ADDENDUM No. 01

Shalimar Elementary School Cafeteria Renovation

September 24, 2026

ARCHITECT – Heffernan Holland Morgan Architecture

Checked By: PDM SH-A10

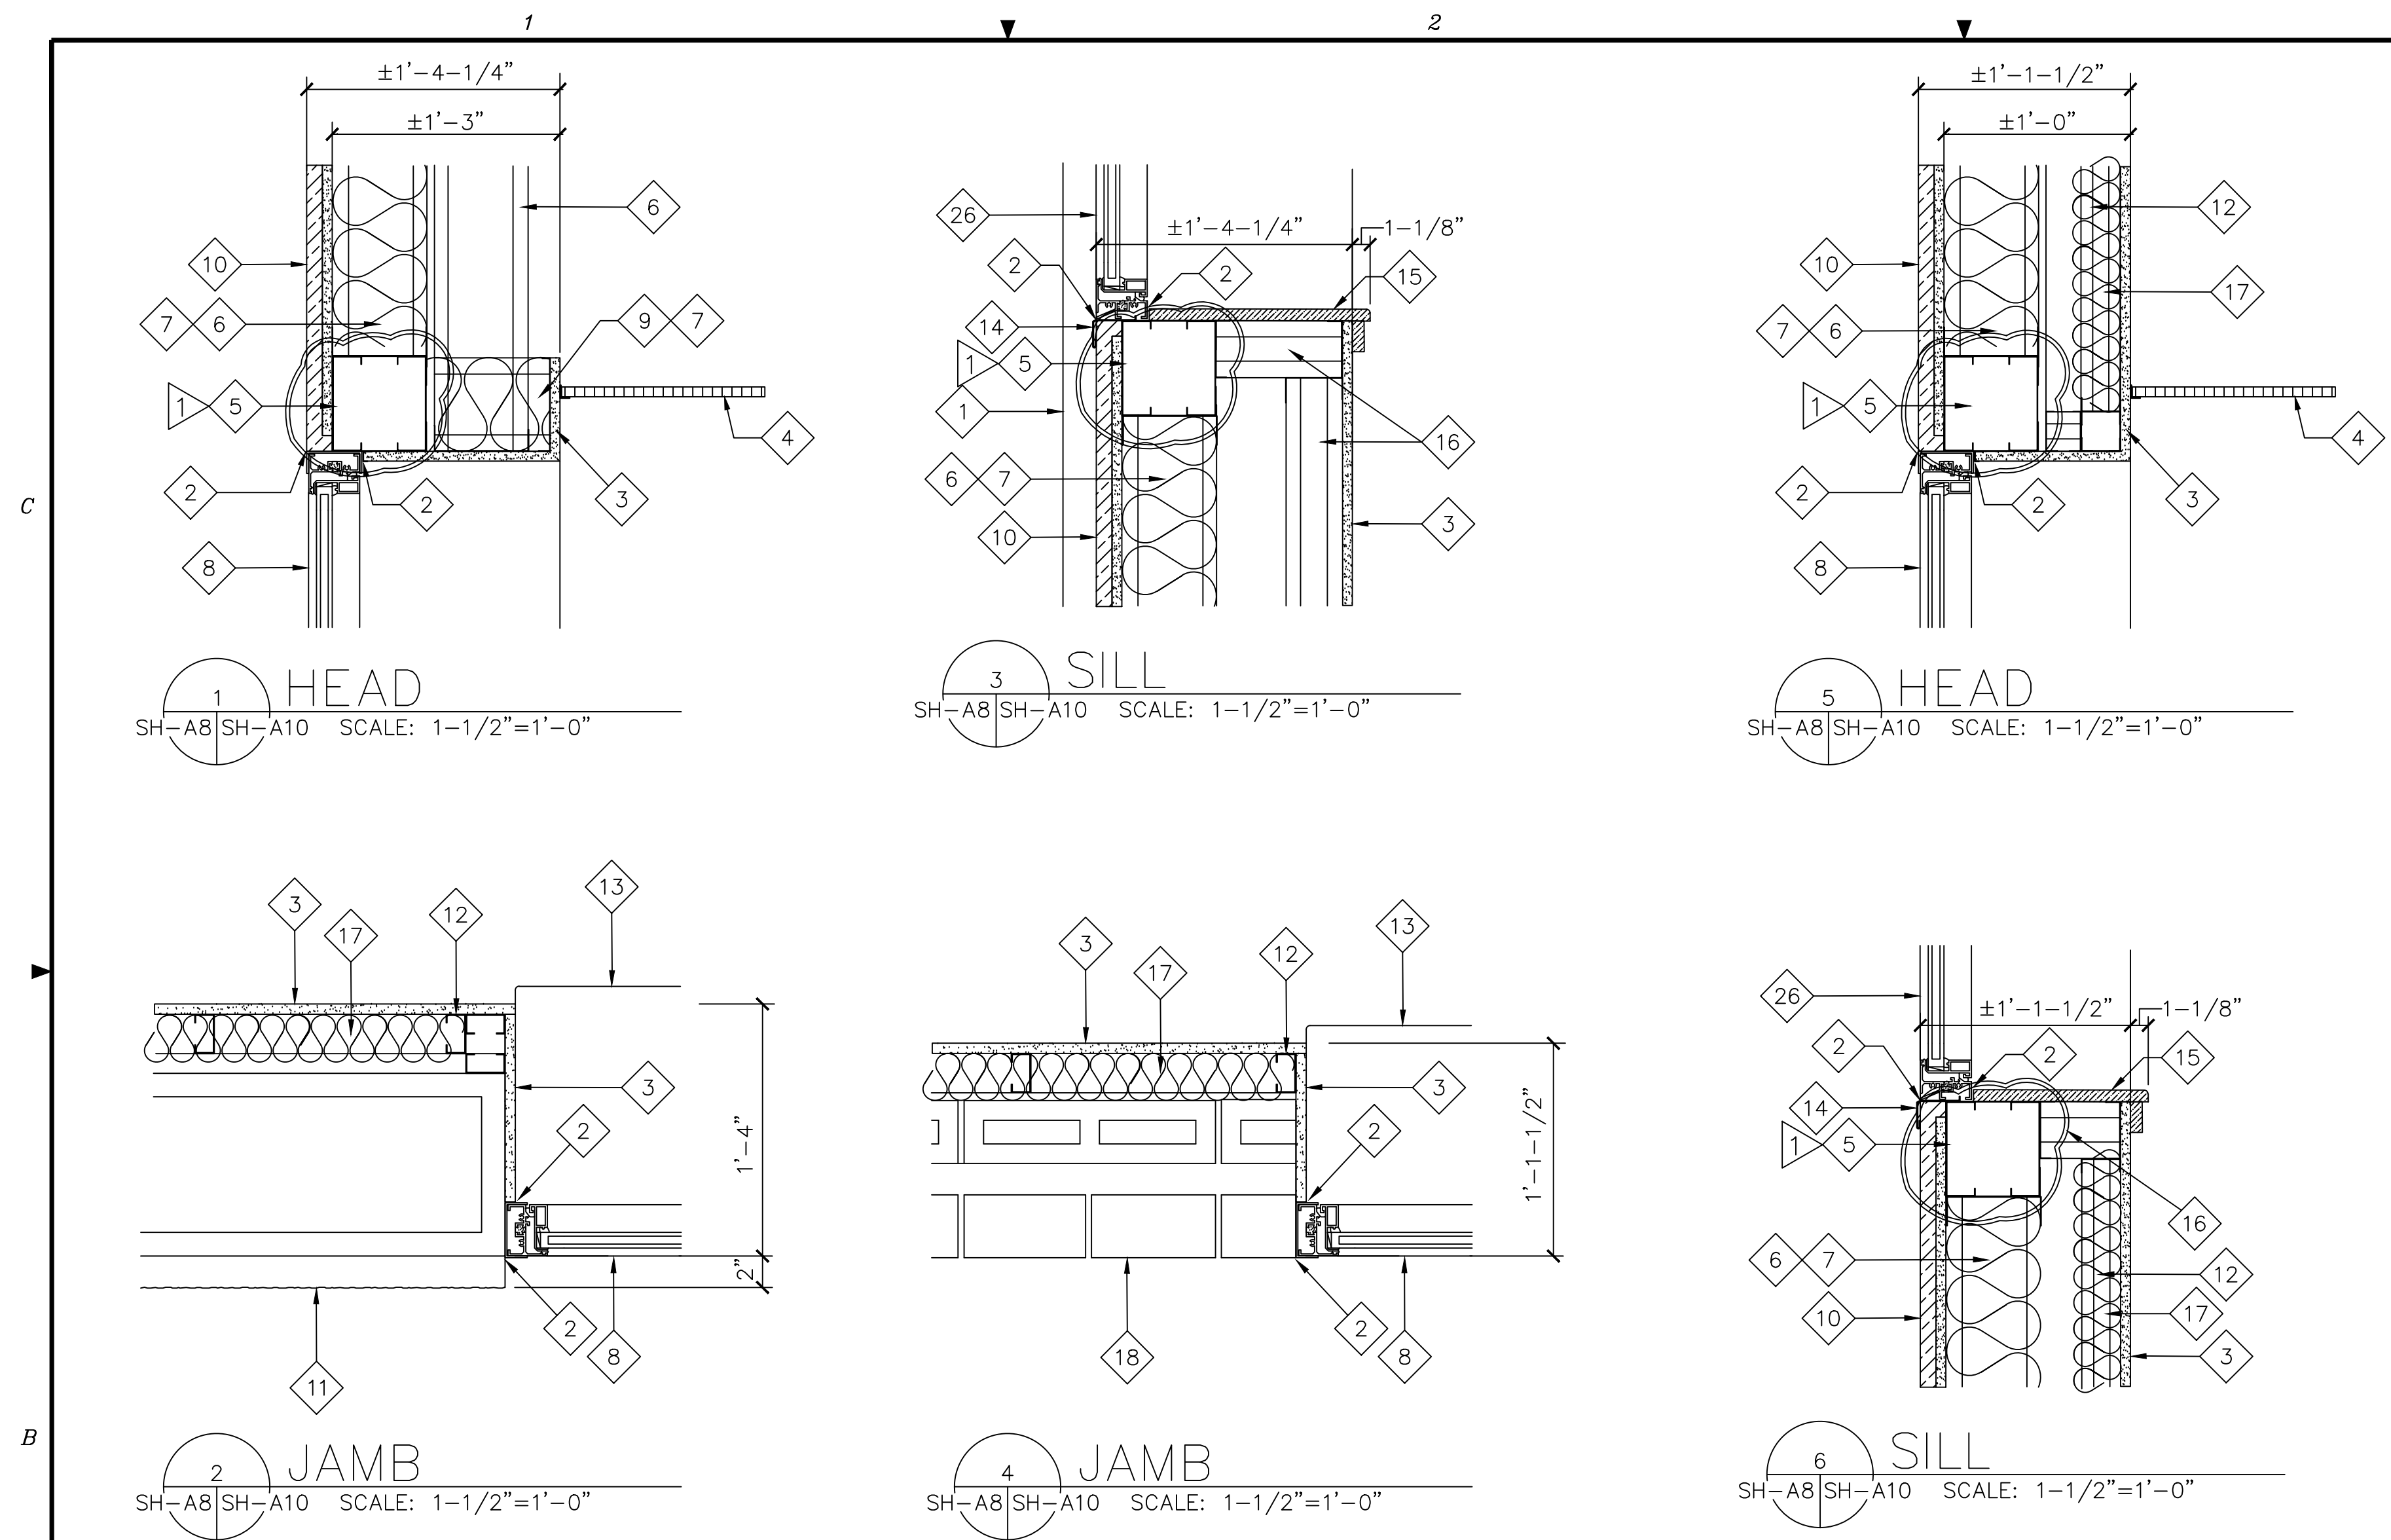
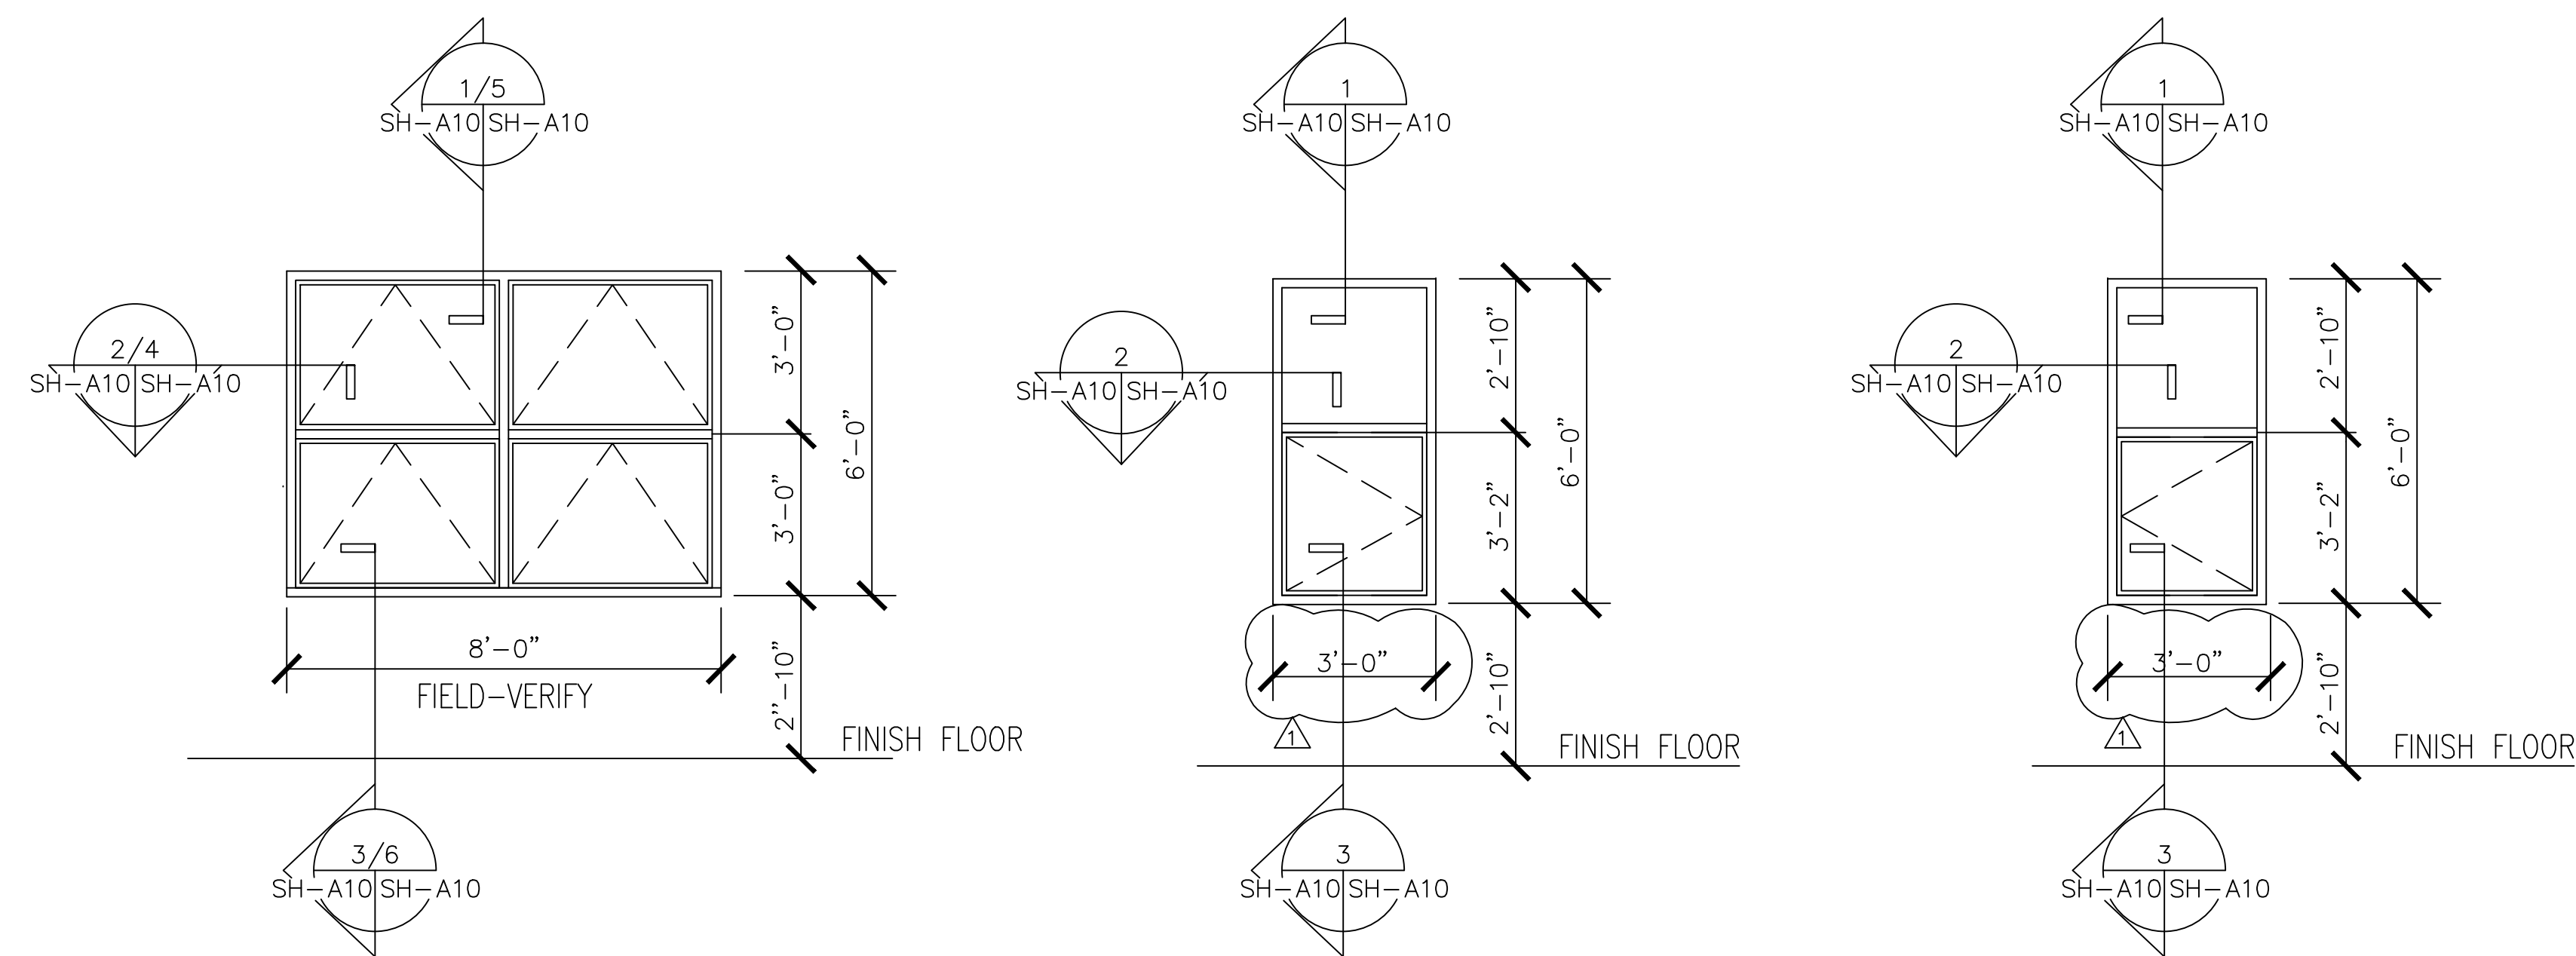
Question: Reference Sheet SH-A10 Key Note 5 regarding new 6" x 3/? HSS steel tube – See Structural. Provide tube thickness and method of attachment and to what; nothing indicated on structural plans.

Question: Reference Sheet SH-A10. Provide width of window type B.

Date:	By:	Description:
9-23-26	JEF	ADD WIDTH TO WINDOW TYPES B & C DELETE STEEL TUBES

Answer: Please reference revised Sheet SH-A10 attached.

Answer: Please reference revised Sheet SH-A10 attached.

ATTACHMENT G - SHALIMAR TEMP FENCING AND CONSTRUCTION LAYDOWN

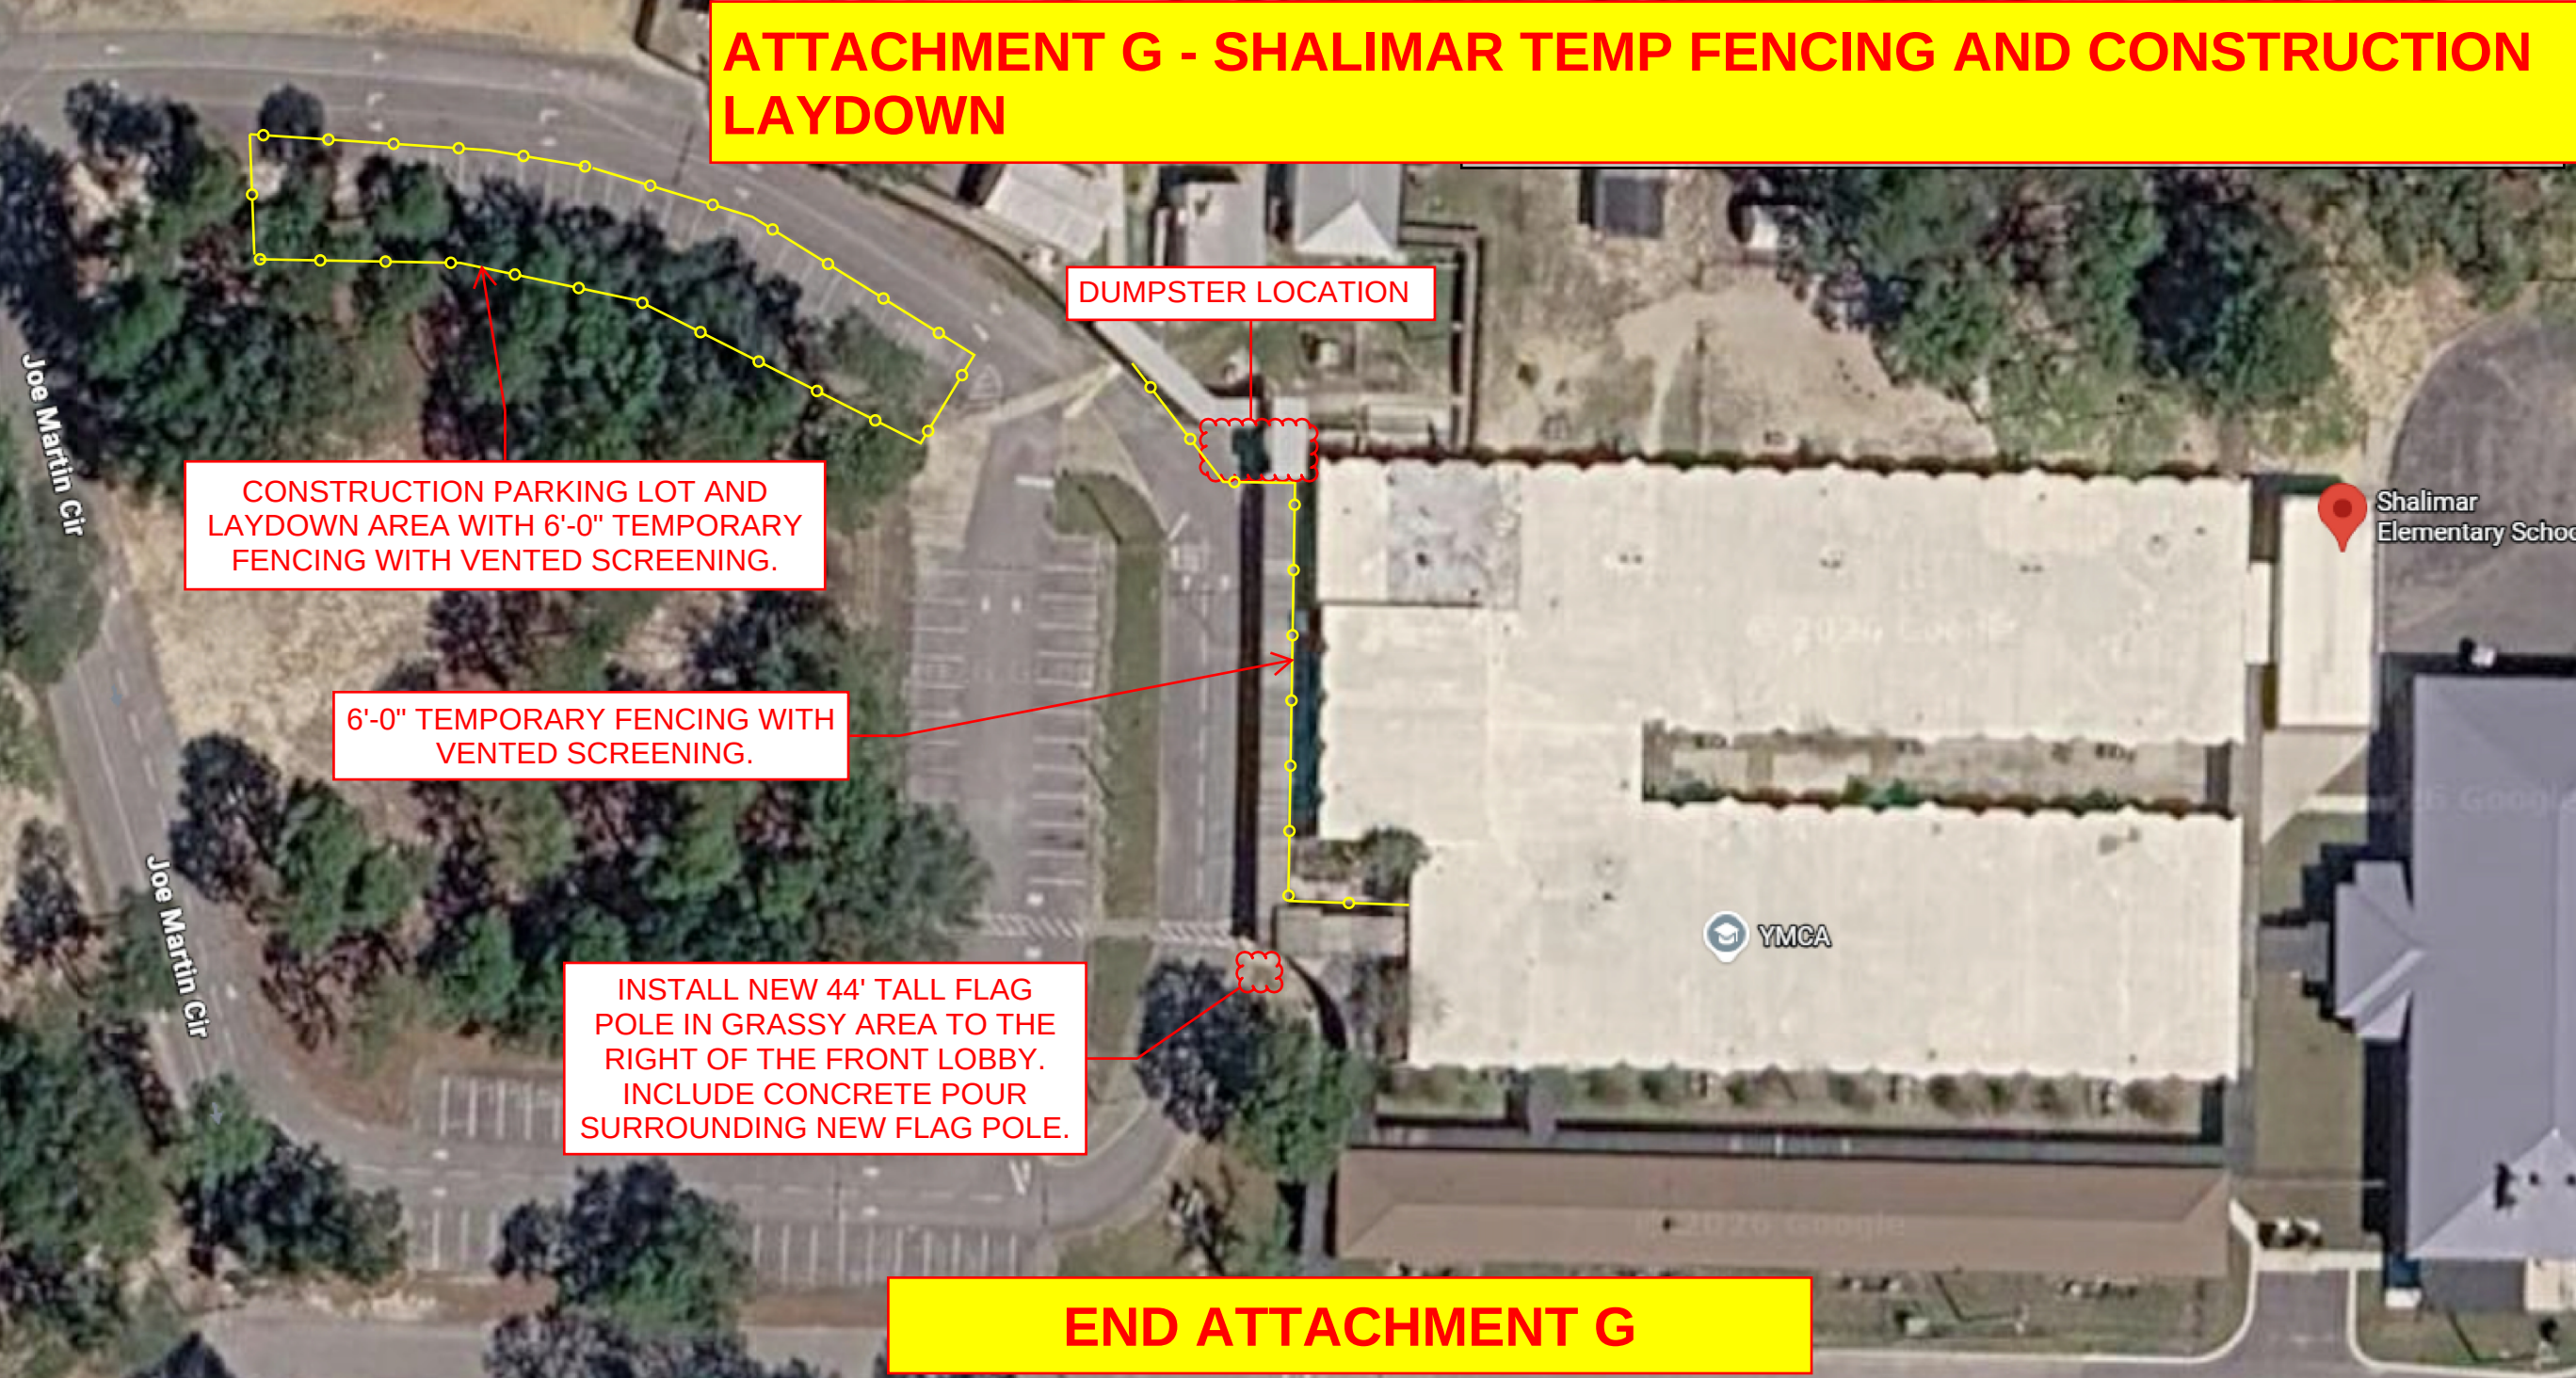
2. **CHANGE:** The Front Lobby portion of this job will be phased. Front Lobby work cannot start until 1 June 2027 and must finish by 30 July 2027. See ATTACHMENT A – FRONT LOBBY PHASED AREA.
3. **ADD:** ATTACHMENT B – SHALIMAR ELEMENTARY SCHOOL ASBESTOS TESTING AND LEAD PAINT SURVEY REPORT.
4. **ADD:** ATTACHMENT C – SHALIMAR ELEMENTARY SCHOOL HYDROSCOUT FINDINGS.
5. **ADD:** ATTACHMENT D – SHALIMAR ELEMENTARY SCHOOL FIRE ALARM AND INTERCOM ALLOWANCE.
6. **ADD:** ATTACHMENT E – SHALIMAR ELEMENTARY SCHOOL FINISHES SCHEDULE.
7. **ADD:** ATTACHMENT F – SHALIMAR INTERIOR TEMPORARY WALL INSTRUCTION.
8. **ADD:** ATTACHMENT G – SHALIMAR TEMPORARY FENCING AND CONSTRUCTION LAY DOWN.
